ADDENDUM #02

Project Name: DOC NCF Misc Door Replacements
DAS# 9523.00
RFB 952300-02
Addendum #02
Dated: October 26, 2026

9523.00 - DOC NCF Misc. Door Replacements

DOOR SCHEDULE & TYP DETAILS

1 DOOR FRAMES & PANELS
SCALE: 1/4" = 1'-0"

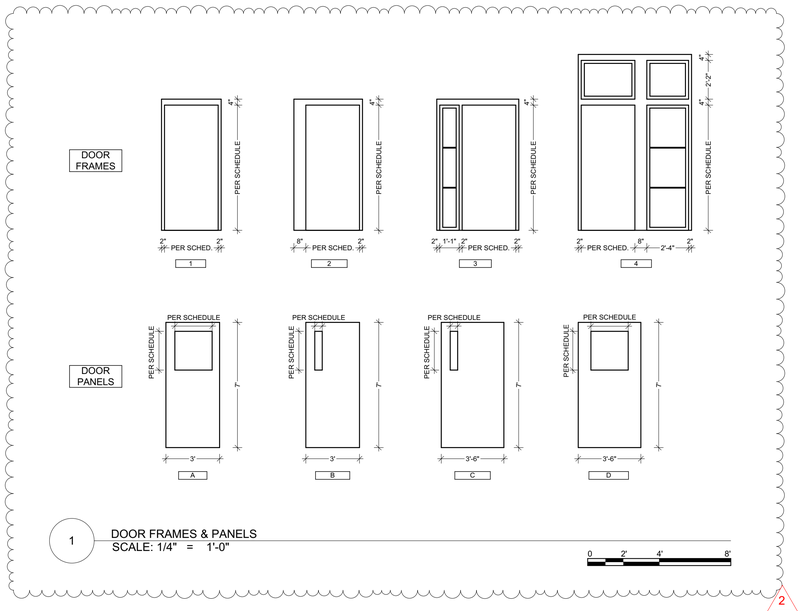
1. Change showing Door H-003 to have a half-lite panel in lieu of a solid panel door.
2. Revised Door H-002 will have door frame #4 in lieu of #5.
3. Revision to Glazing key with lite sizing.

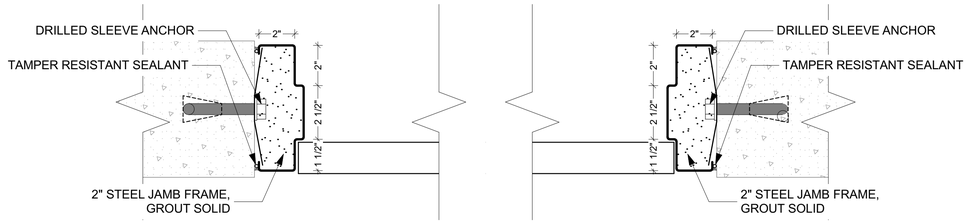
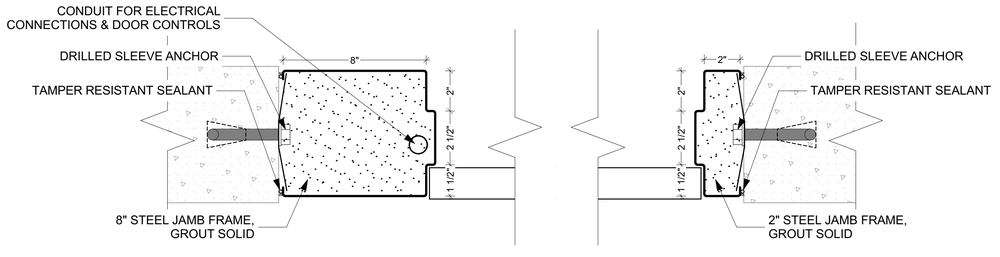
A. Frame cut out for Doors H-007 & H-003 – cut and replace existing frame leg to be verified in the field – Existing hinges to remain.
